NEW SAYERS FOOD STORE

SUBJECT	Addendum No. 2	PROJECT	2102
DATE	September 17, 2021	PAGES	2

ADDENDUM No. 2

DRAWING NUMBER
C-01

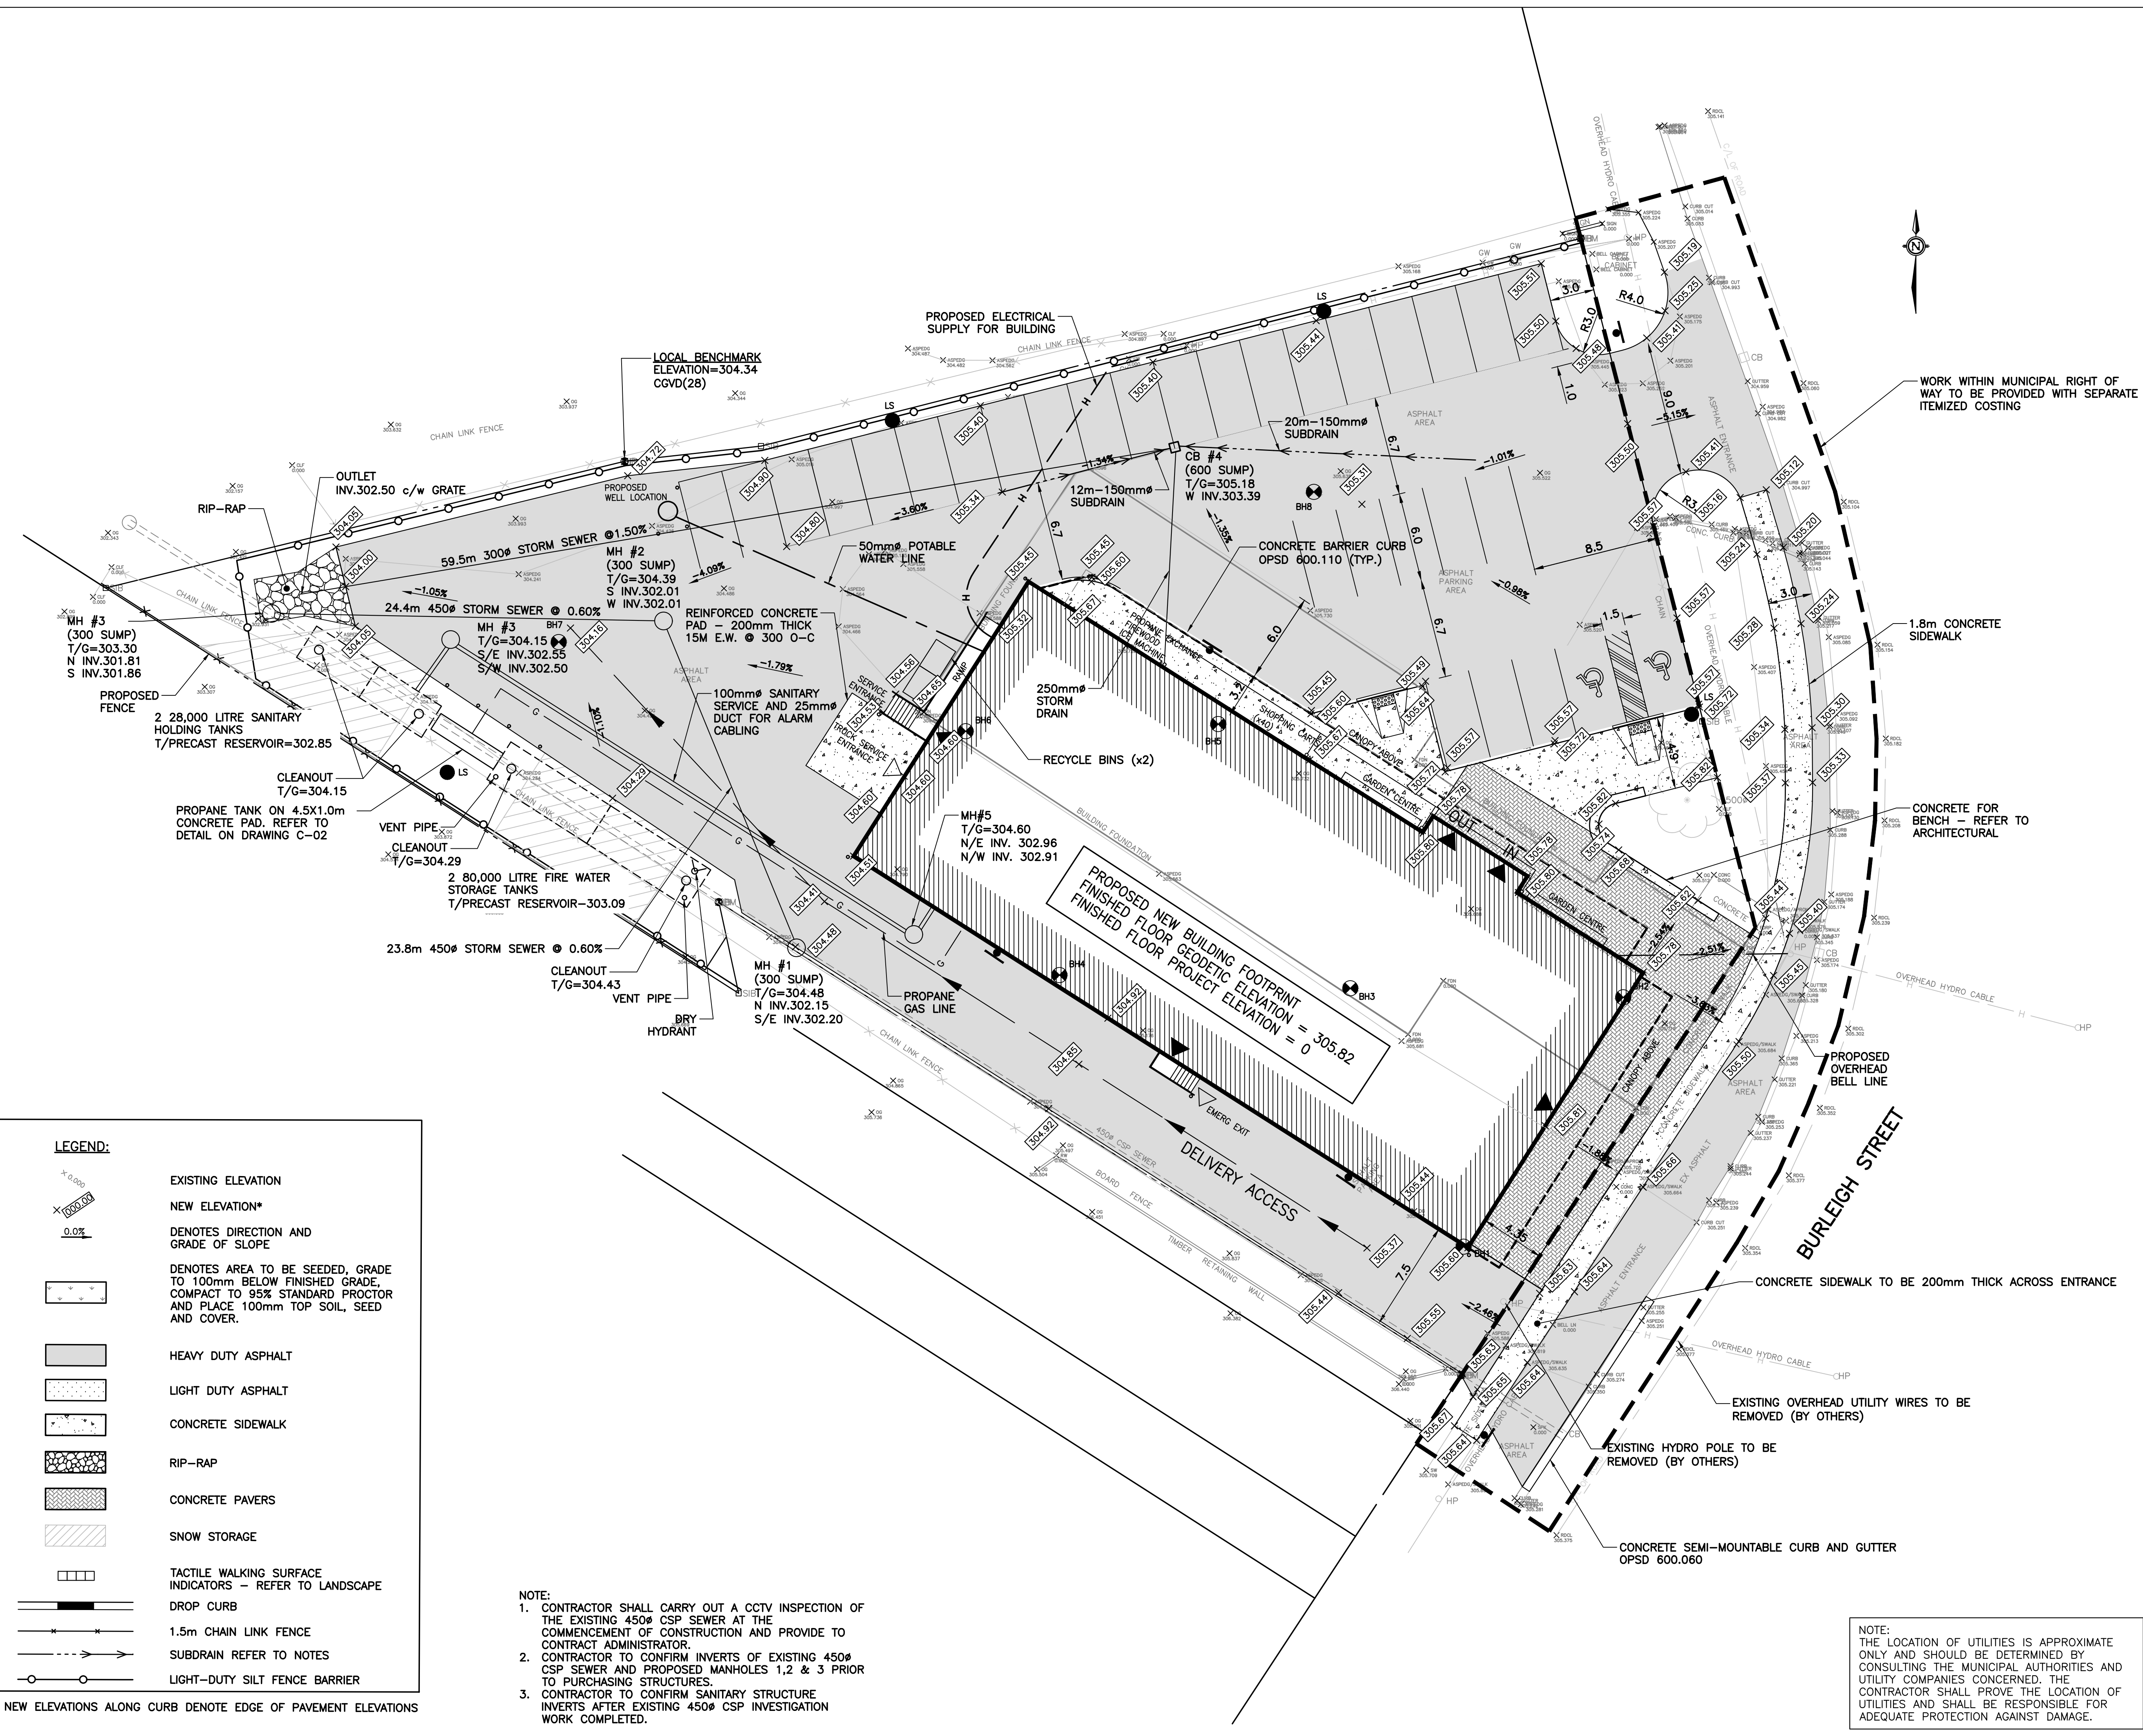
Drawing C-01- Construction Grading & Servicing Plan

- a) **REVISE** Location of Well to north-west corner of property;
- b) **REVISE** Storm Drain to 250mm diameter;
- c) **PROVIDE** Work within municipal right of way to be provided with separate itemized costing (See Architectural Addendum 1);
- d) **PROVIDE** Semi-mountable curb and gutter OPSD 600.060;
- e) **REVISE** Location and scope of building sanitary service connection to sanitary holding tank;

DRAWING TITLE
SITE PLAN
 SCALE
1:200
 DATE
SEPTEMBER 9, 2021

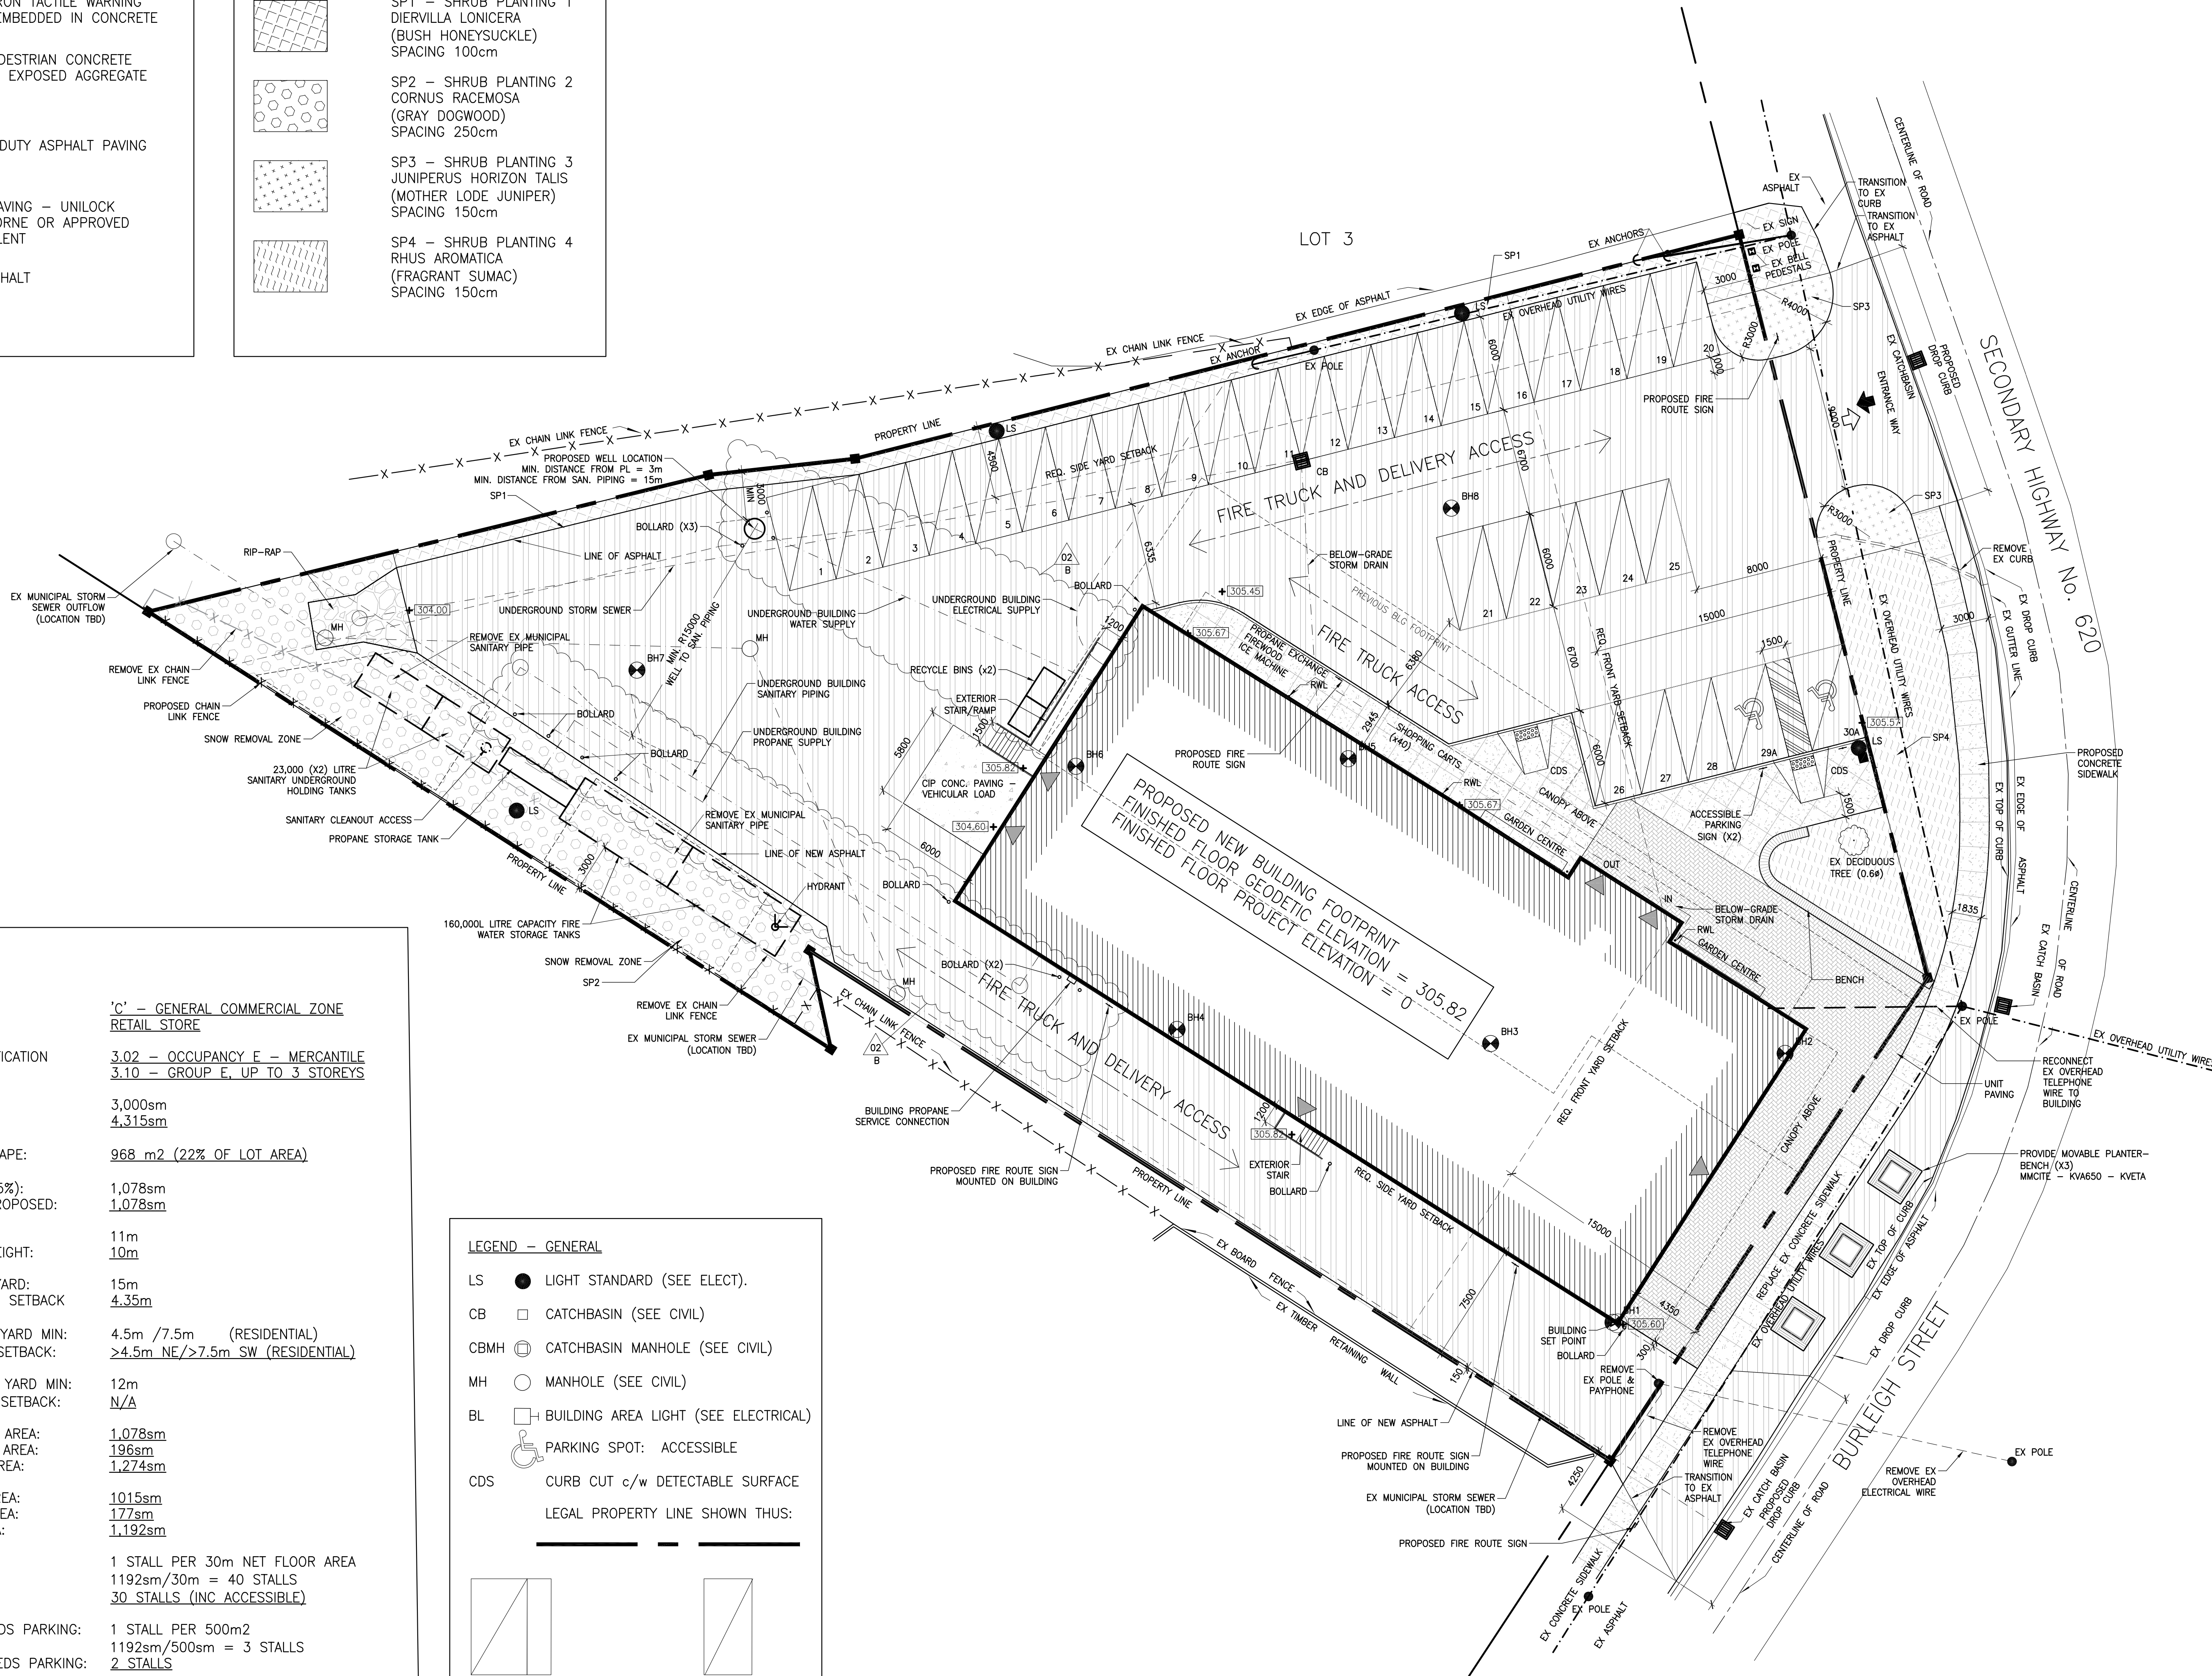
Drawing A002 – Site Plan

- a) **REVISE** Location of Well to north-west corner of property;
- b) **REVISE** Gas and Sanitary piping entry locations to building;
- c) **PROVIDE** Bollard Protection for well and gas;

SHEET TITLE:
FOUNDATION PLAN

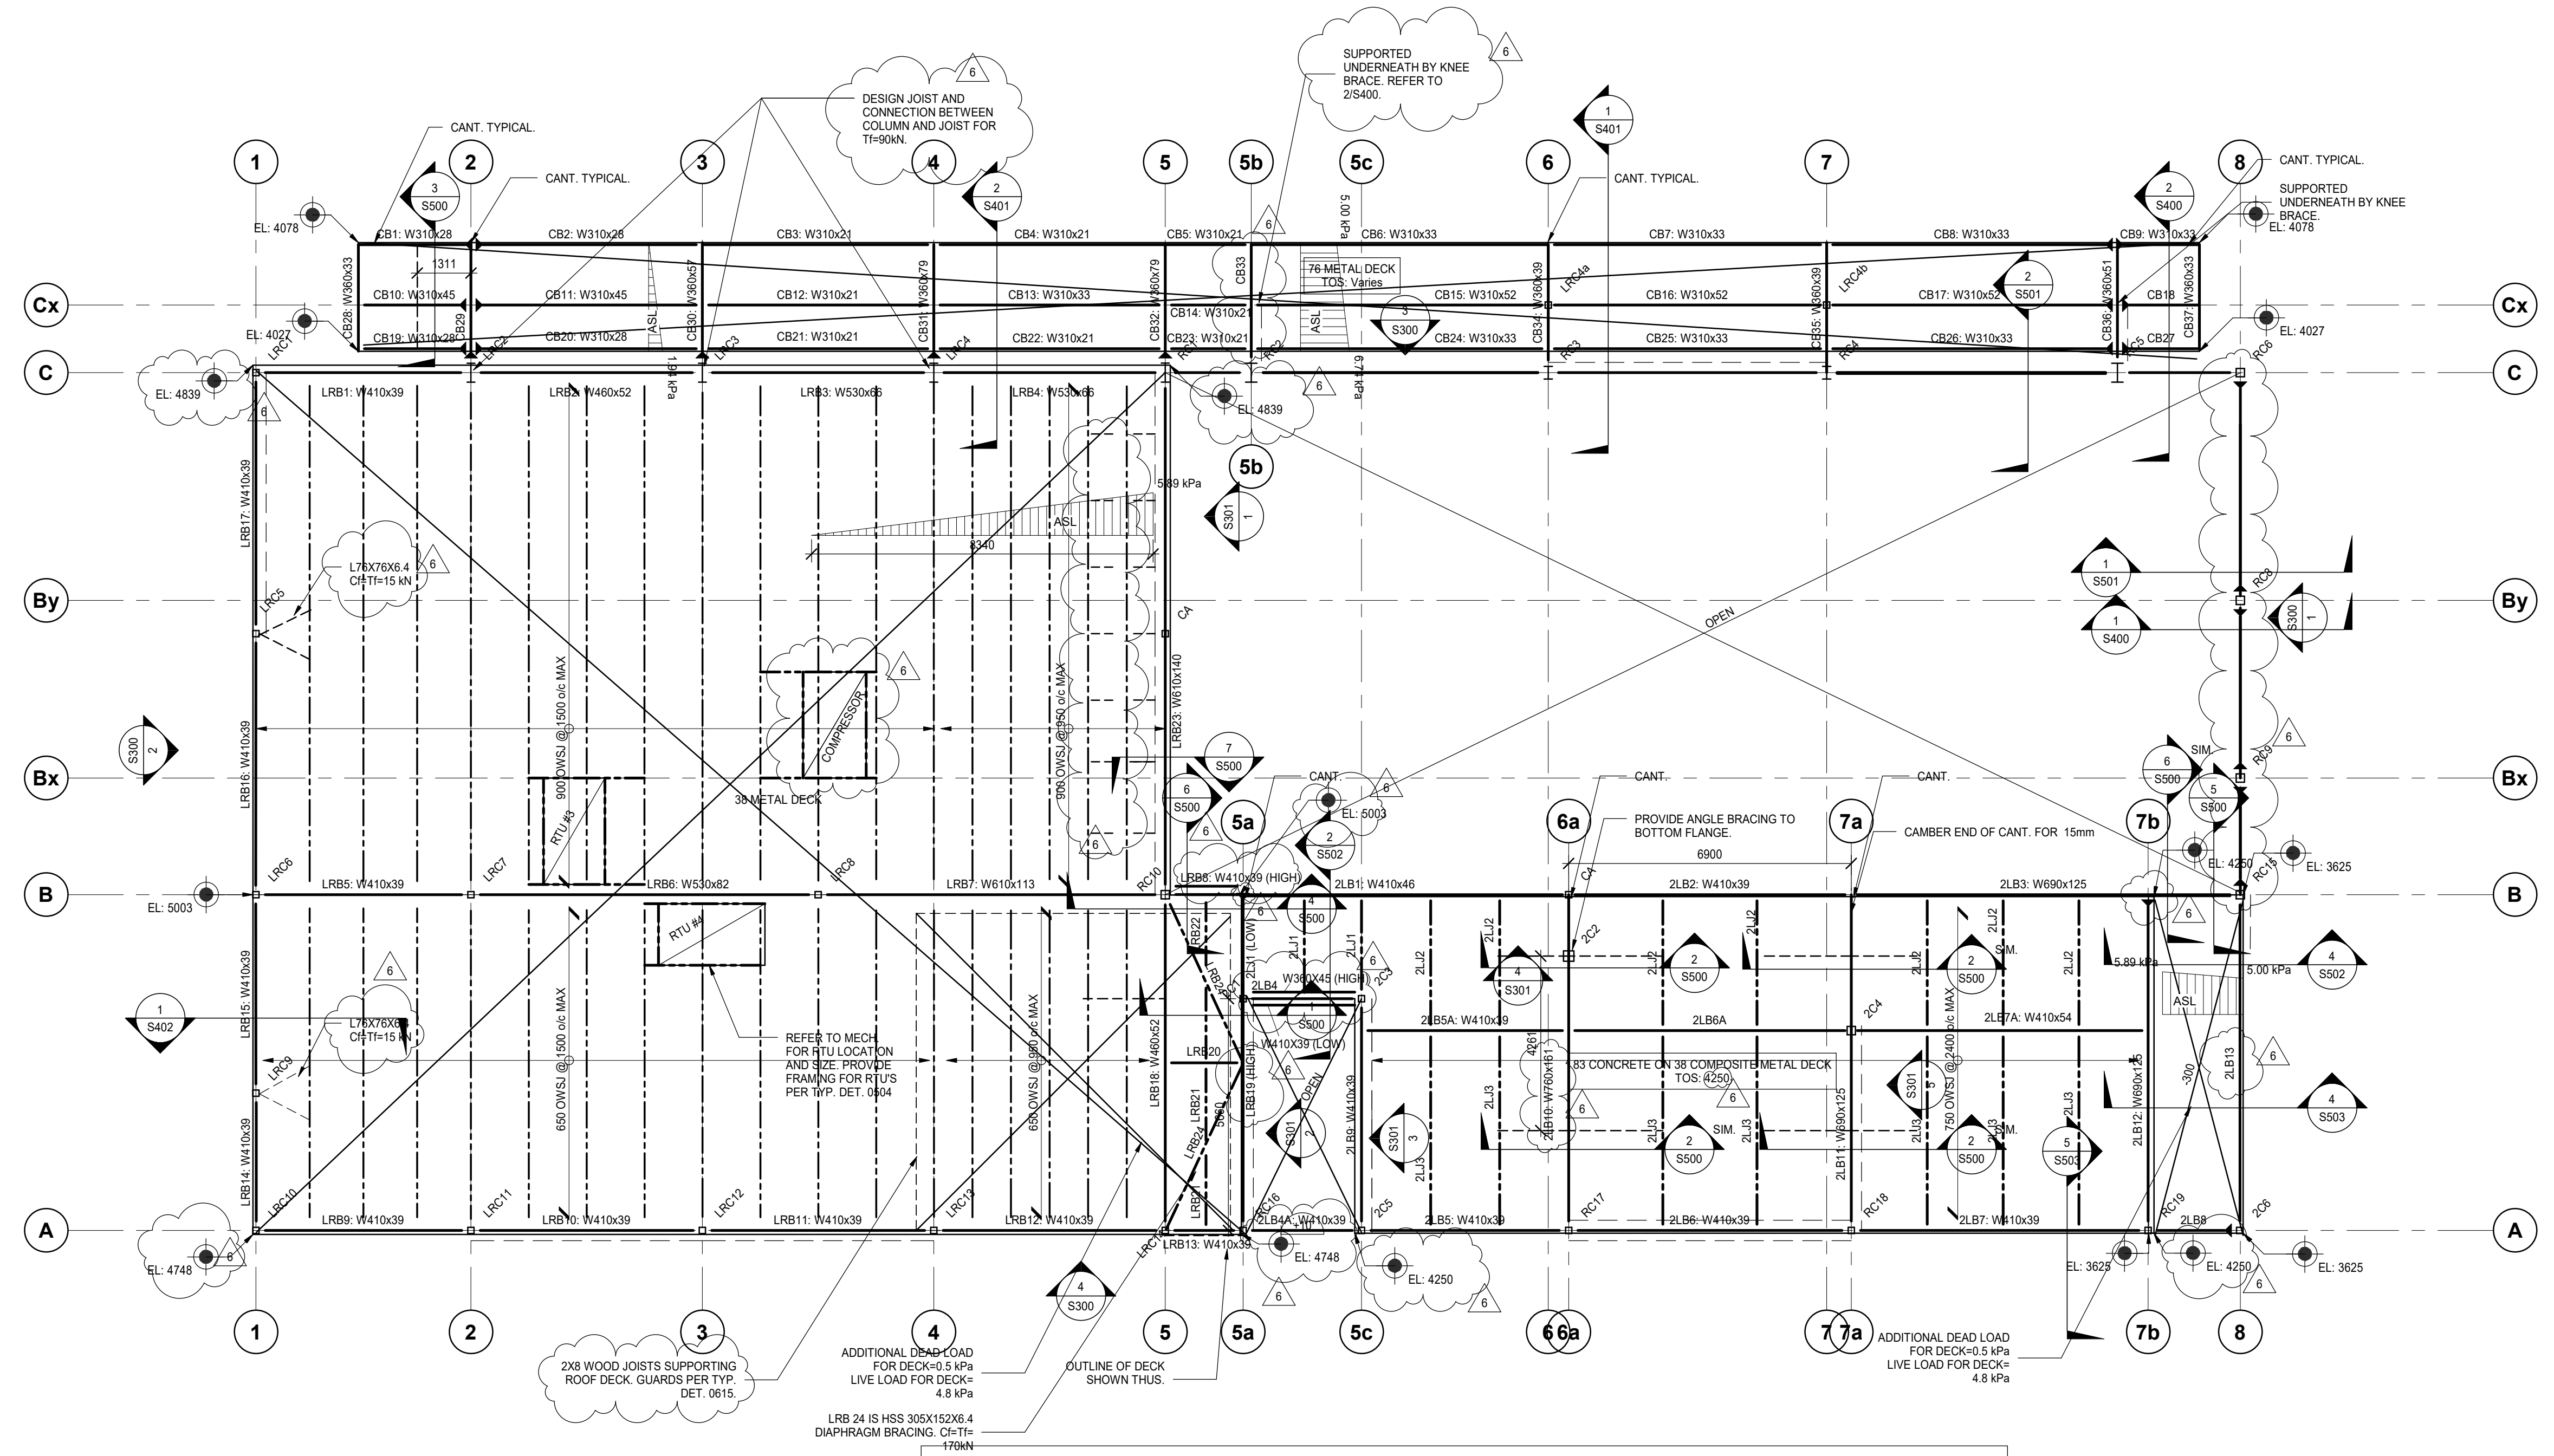
S-100 Foundation Plan:

1. Revise S100 as bubbled.
